**Public Comments on NIST Draft Final Report
NCSTAR3**

**“Technical Investigation of the May 22, 2011
Tornado in Joplin, Missouri – Draft Final Report
for Public Comment”**

NIST NCSTAR 3 Technical Report on the May 22, 2011 Tornado in Joplin, Missouri

SAVE Photo 1 – Northwest corner looking northeast

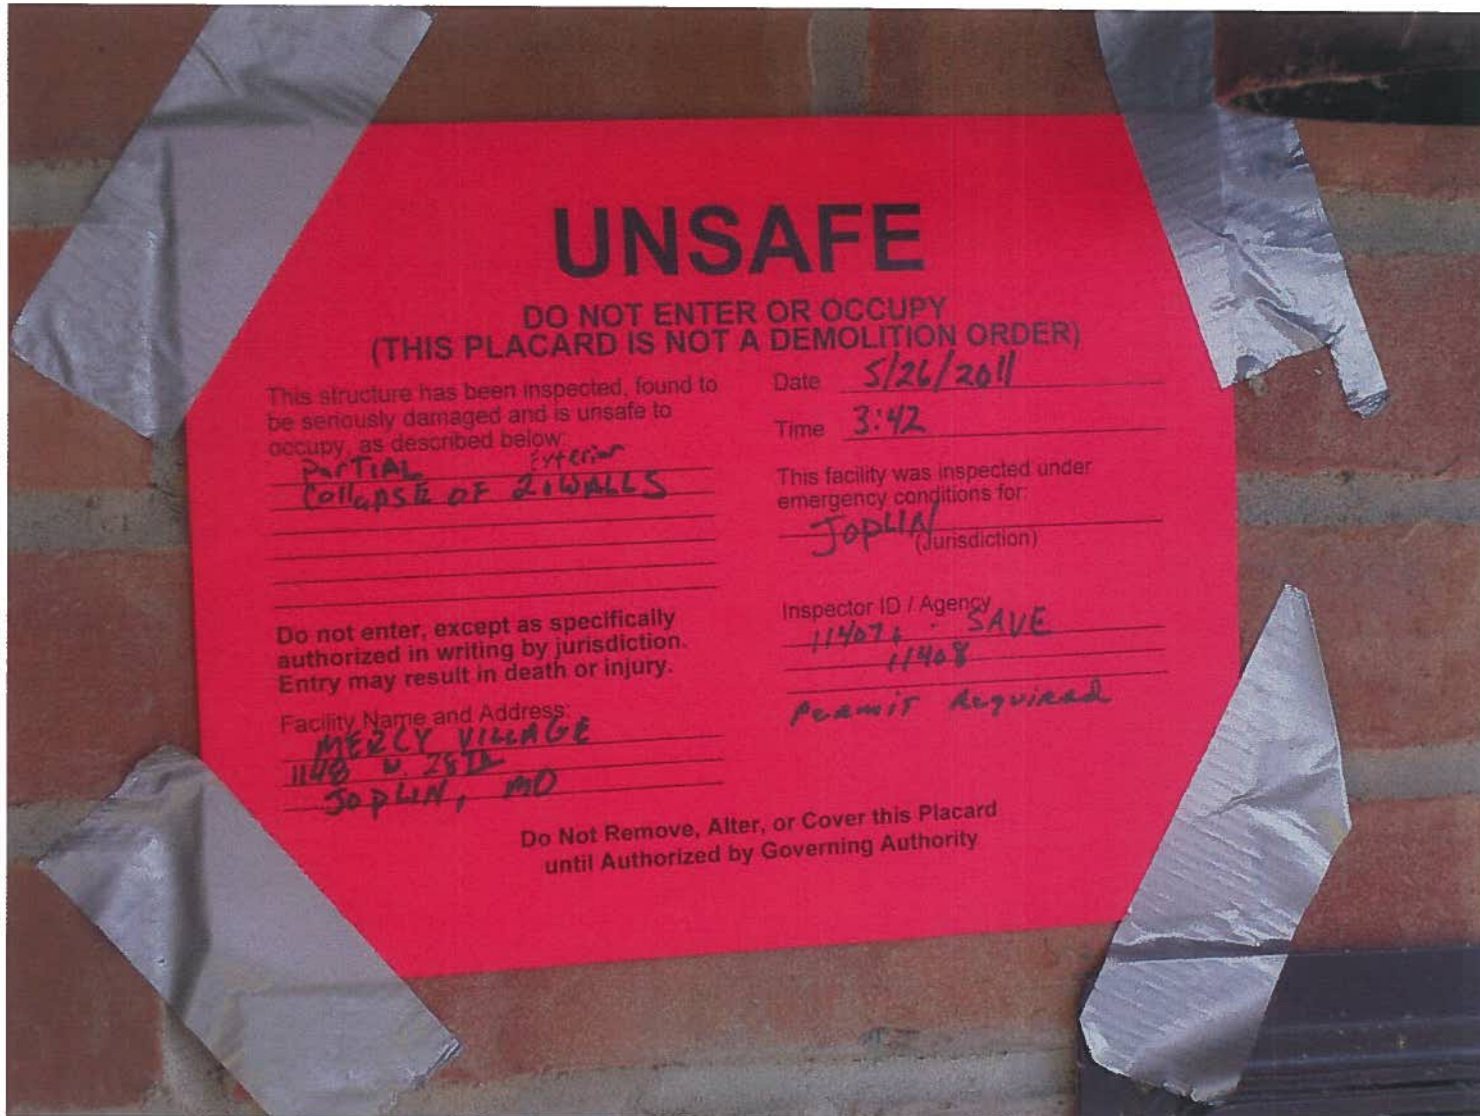
- 4) Page 195. The damage description should be revised to reflect the higher degree of damage that this structure actually suffered. The bullet points concerning the photos should include "loss of roof sheathing and sections of roof framing." See attached SAVE photos 1.

- 5) Page 196, Figure 3-11, see attached. The caption should include "roof framing and sheathing" to include the damaged roof dormer shown on the right side of the photo. See attached SAVE photo 1.

- 6) Page 196, Figure 3-12, see attached. This photo shows a POST event repair to the third floor roof and walls which misleads the reader as to the level of damage this building sustained. See attached SAVE photos 1-4. The entire third floor wall at the south end of the building was removed by the tornado. Load bearing walls at the south and east ends of the building were separated from the roof and pushed out of plumb. SAVE photo 3 should be used in your report instead of the photo showing the post event repairs.
